In reference to your concerns expressed at the Sanford November 30, 1979 DER hearing on our proposed COM test facility, attached are our responses.

ANSWERS TO SUPPLEMENTARY QUESTIONS FROM DER

FLORIDA POWER & LIGHT Co.  
 SANFORD STATION  
 COAL/OIL MIX FACILITY

The following is a summary of various points of information which we feel you need to address at the November 30, 1979 public hearing in Sanford on FP&L's variance request for test burning of various coal-oil mixtures in Unit #4 at the Sanford power plant.

FIGURE 1

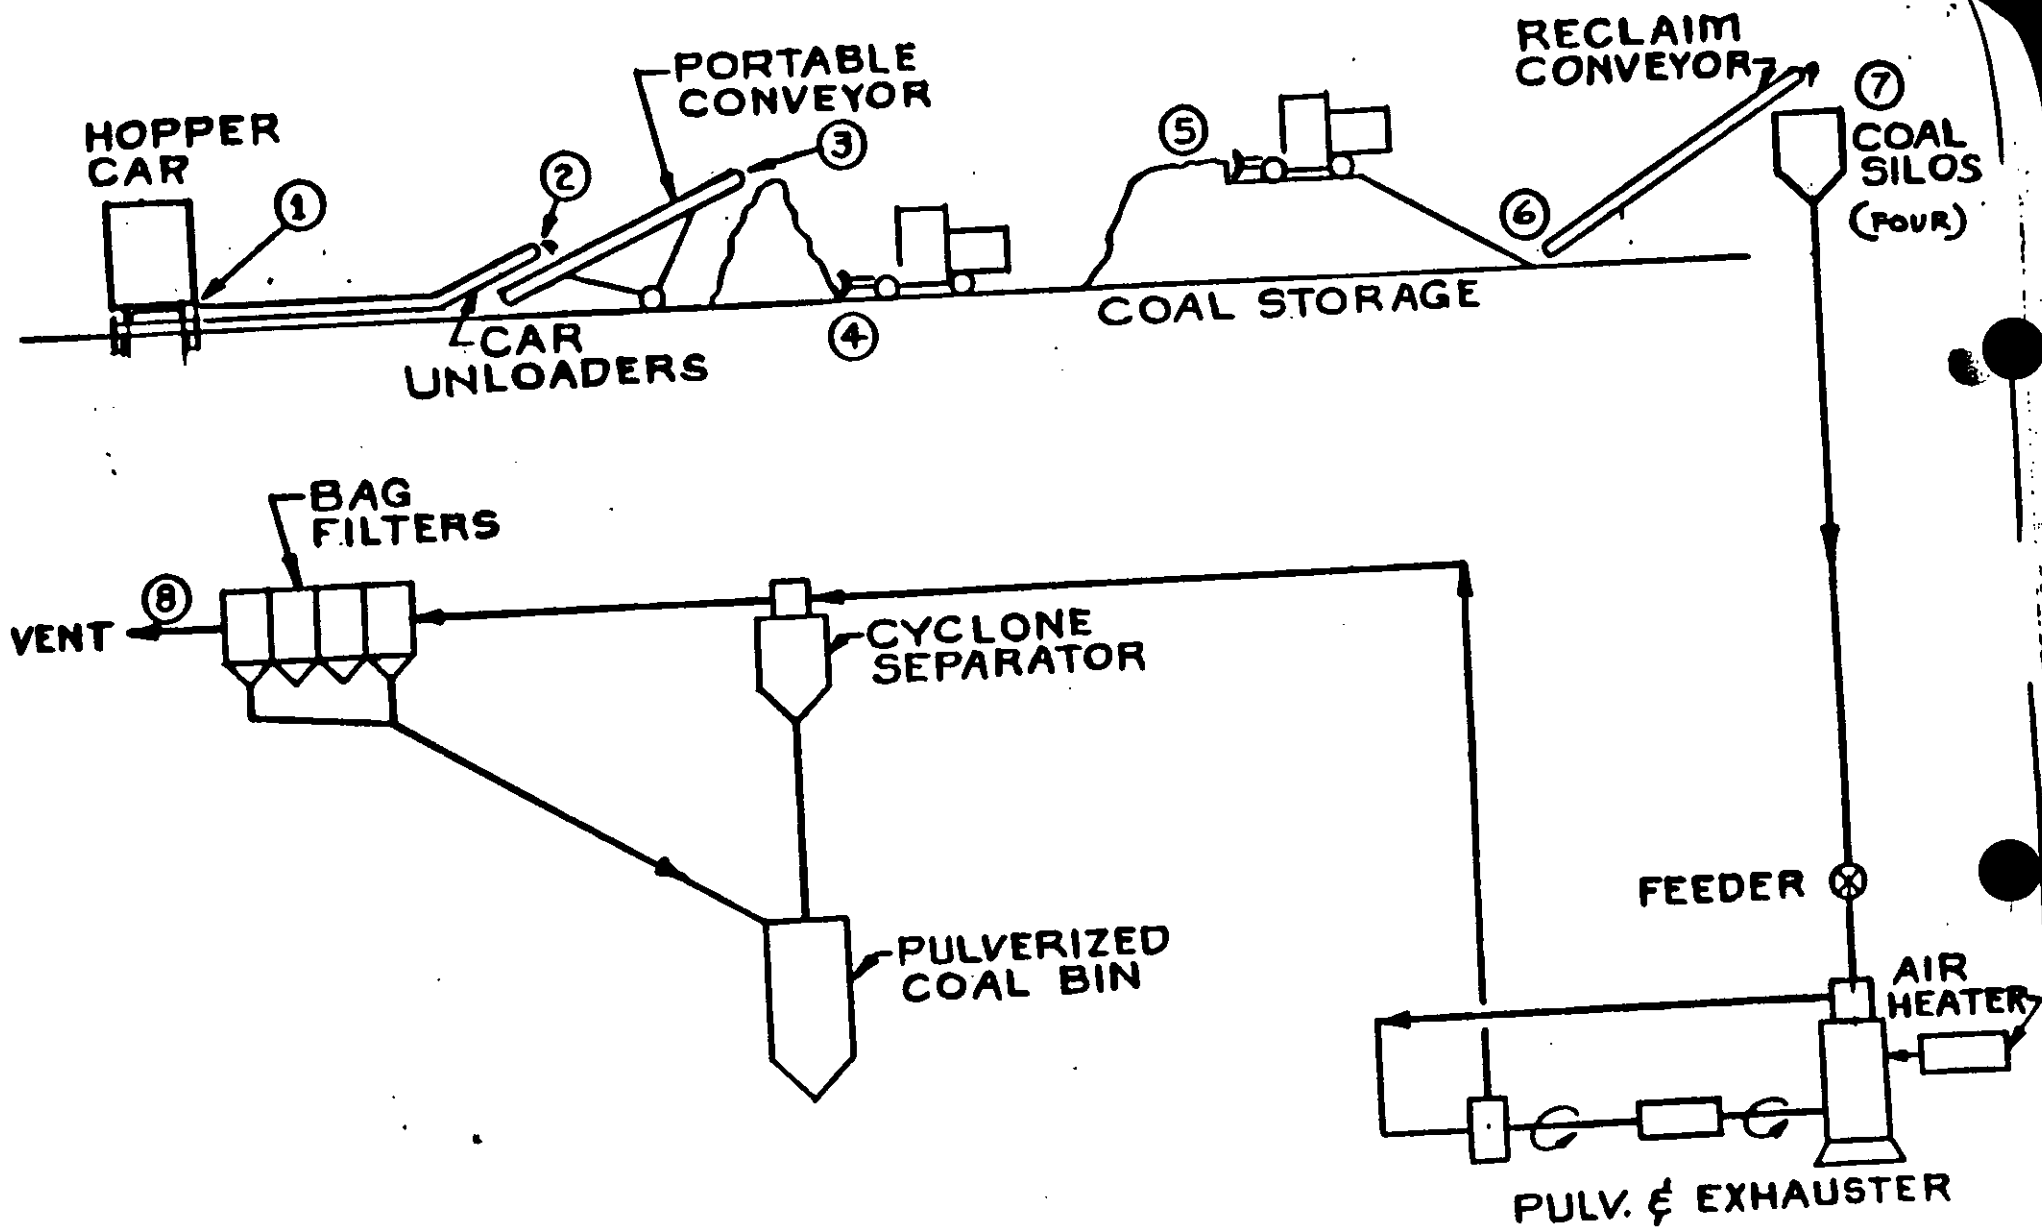
The sources of fugitive coal dust emissions are shown on Figure 1. Quantitative data on fugitive coal-dust emission from coal unloading, storing, conveying, transferring, etc., are very limited. The available emission factors for coal handling operations are, at best, rated below average to poor. However, fugitive coal-dust emissions can still be roughly estimated using these emission factors as presented in Table 1 (Reference 1). Estimates of fugitive emissions in Table 1 include particulates up to 100 $\mu$ m in size (Reference 1). A major proportion (~70%) of the particles settle out within a short distance from the source and the long range air quality impacts are, therefore, relatively insignificant. Although the proposed PSD regulations allow credit for reductions due to such control measures for the purpose of PSD review, no credit is taken for emission reductions from compacting, water sprays and the higher quality coal (washed and not easily friable) to be utilized at this facility.

Due to the smaller free-fall distance to the car unloader, fugitive coal dust emissions due to this source are expected to be significantly less than those shown in Table 1 for Source 1 (Figure 1). The unloaders transfer (source 2) coal onto a conveyor belt which then stacks the coal on a temporary coal pile (source 3). Mobile equipment (source 4) moves the unloaded coal to a storage pile.
